**Subject: Lobo Plaza Traffic Impact Study
East of I-25 and Lomas Blvd.
Albuquerque, New Mexico**

This letter is to inform you that the **FINAL** Traffic Impact Study (TIS) for the Lobo Plaza TIS east of the I-25 and Lomas Blvd interchange dated February 2026 has been reviewed.

EXHIBIT A

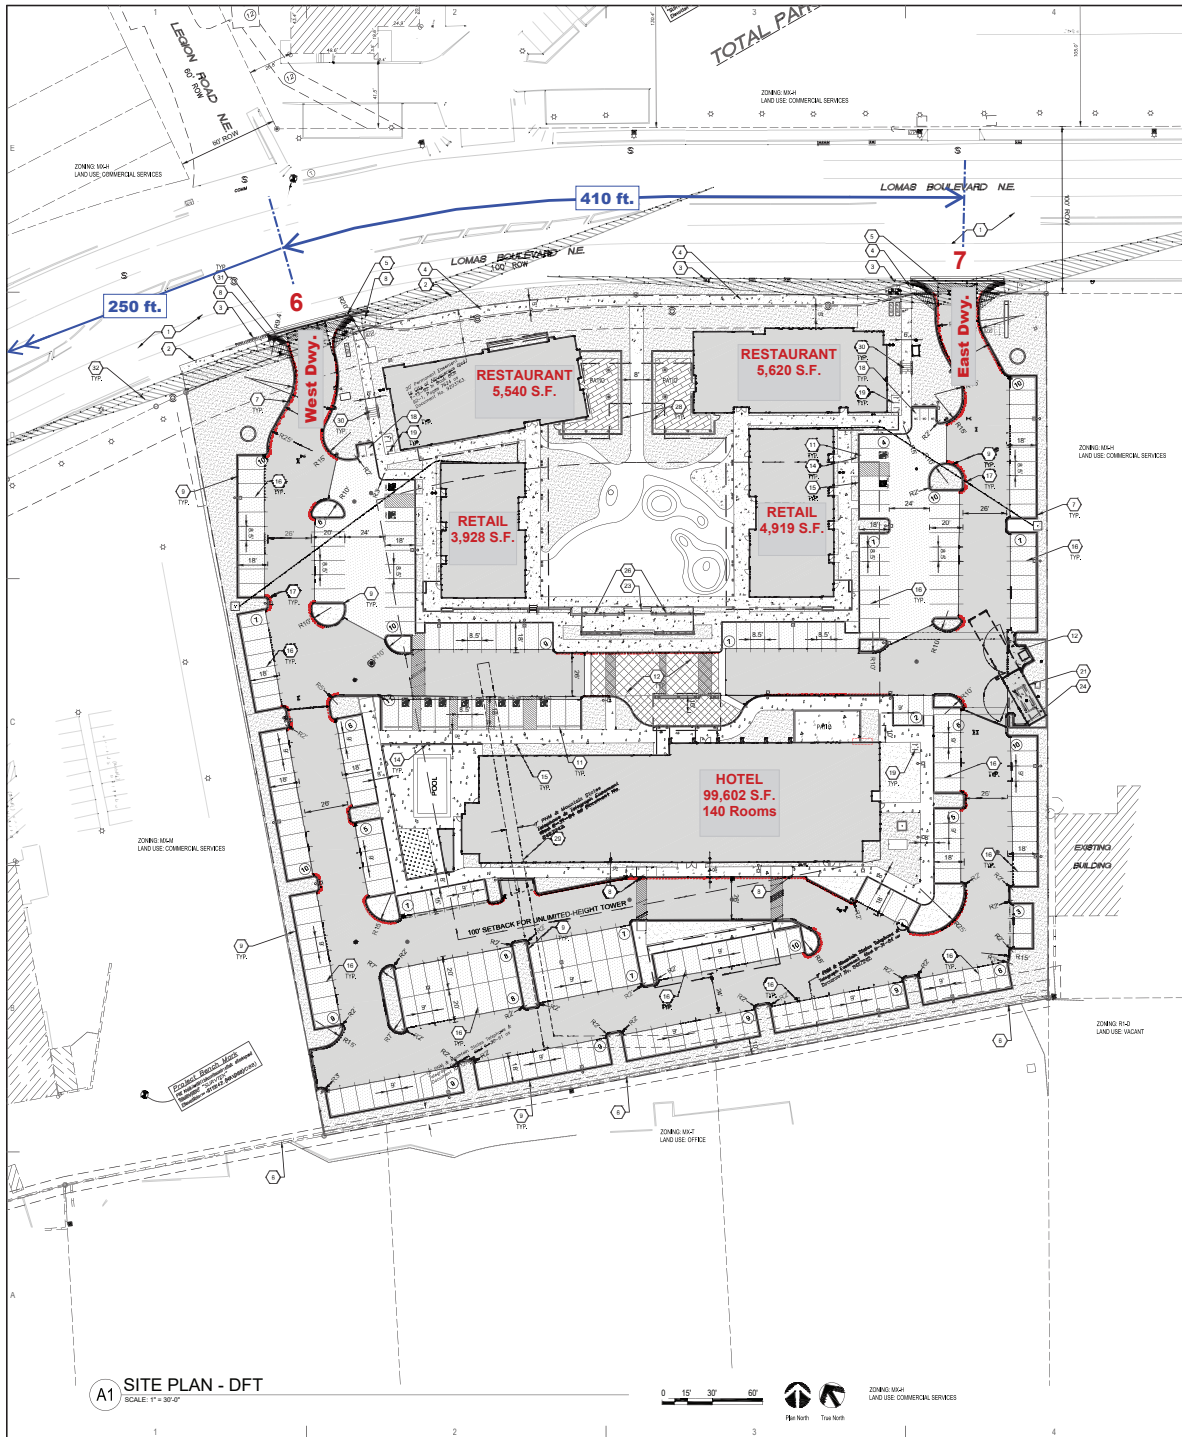
The NMDOT has no objection to using the existing full signalized intersections at the I-25 and Lomas Blvd. interchange. The site plan for this development is shown in Exhibit A. The recommendations provided for these analyses are shown in Exhibit B. Based on these analyses, the following conditions are required:

1. At the signalized intersection of I-25 southbound off-ramp and Lomas Blvd. the development shall provide signal timing recommendations to optimize operations as shown in its mitigated scenario. These signal timings shall be provided to the City of Albuquerque Traffic section for its implementation.
2. At the signalized intersection of I-25 northbound off-ramp and Lomas Blvd. the development shall provide signal timing recommendations to optimize operations as shown in its mitigated scenario. These signal timings shall be provided to the City of Albuquerque Traffic section for its implementation.
